Product change notification (PCN)

Title / short description	Housing design change
Affected article category	Measurement and control technology
Change category	Form and appearance
Change number	CCK220131-01
Reason for PCN/PDN Revision	Housing revision

PACT MCR- old and new design

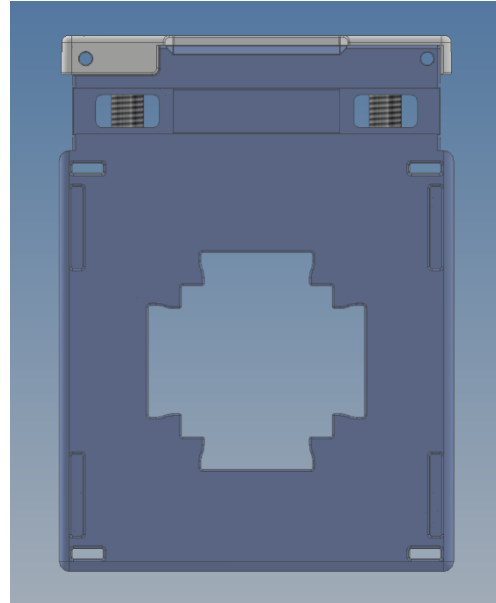
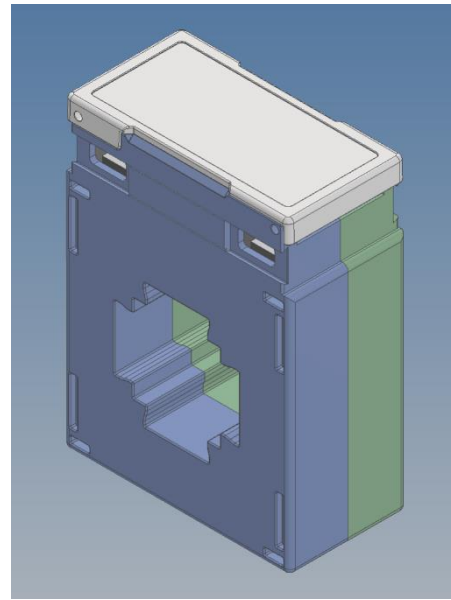
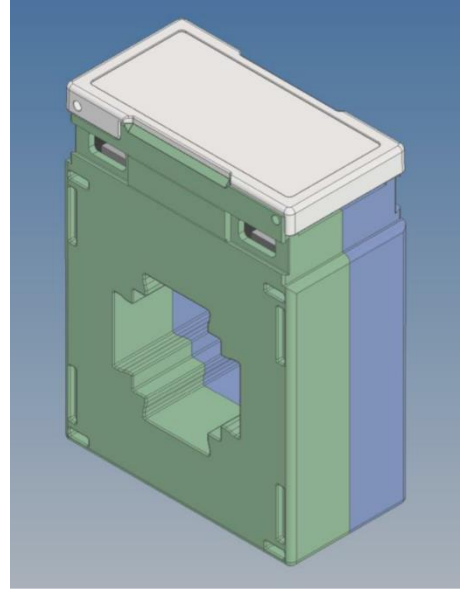
The PACT current transformers will soon exhibit new housing features that enable additional advantages for the application.

Among other things, a rotatable secondary terminal cover (captive) will be installed on the current transformer in the future, with which the four secondary terminals will either be made accessible by means of a 90° rotation or provide safe touch protection without twisting.

Furthermore, the colors of the current transformer housings are changing:

- The secondary terminal cover is changing from green to orange (RAL 2003)
- The housing color including all accessories is changing from black to gray (RAL 7042)
